City of Alexandria, Virginia

MEMORANDUM

SUBJECT: 213 SOUTH FAIRFAX STREET
BAR2012-0262 and 263

ISSUE: Partial Demolition/Capsulation; Certificate of Appropriateness for Alterations and Addition

Roof Plan

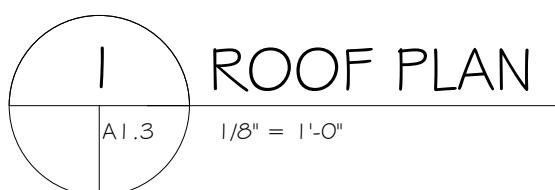
The applicant met with the neighbors and has responded to the Board's comments with a revised submission. The revised submission includes a slight re-design of the addition's roof, which lowers the east cornice of the addition and aligns it with the cornice on the rear ell. Additionally, the second floor east elevation windows have been converted into a gabled dormer with a set of paired, nine-over-nine windows. An additional window was added to the second floor of the south elevation to relieve the visual mass of this wall. Finally, the applicant has also offered to purchase three new trees for the neighbor's property, to mitigate the removal of two existing trees on the subject property that served as green privacy screening.

The applicant has submitted a revised design which addresses the concerns raised by the Board and the neighbors. The cornice height of the addition, as viewed from Fairfax Street, has been reduced and the roof forms simplified. Trees have been offered which will replace the lost tree canopy and soften the view from the neighbors and the street. The applicant has also submitted a plan sketch of this block based on the building footprints from the 1907 Sanborn Insurance maps which have been overlayed on the City's current real estate maps. This sketch shows the very modest size of the proposed addition relative to the large 20th century additions that have been approved on the neighboring houses.

Area to be capsulated with new addition

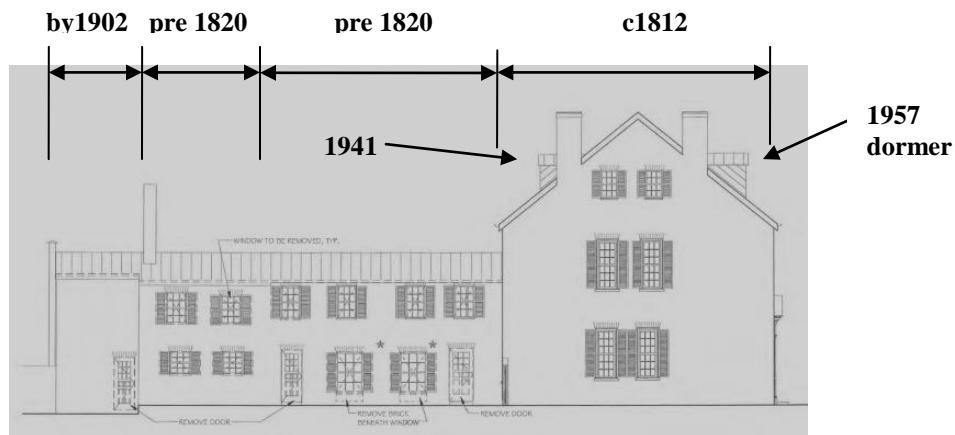
The proposed two-story addition will capsule the north wall of the later c1885 and 1902 additions and only one bay of the pre-1820s ell (see illustration below.)

The proposed capsulation is to be located on a secondary elevation, is barely visible from a public ROW and most of the current exterior walls will remain intact. The Board generally supports additions which follow these practices. Staff has examined the windows proposed to be replaced on the ell and has found the existing sashes are modern replacements, many with aluminum jamb liners and nailed butt joints. Additionally, the two windows on the first floor proposed to be demolished were shortened in a previous kitchen renovation. Also, it appears that only one or two of the windows and doors still retain the original early-19th century beaded trim. Based on these findings, Staff does not object to the proposed full-frame replacement of the windows on the addition with SDL, painted wood windows with a 5/8" muntin.
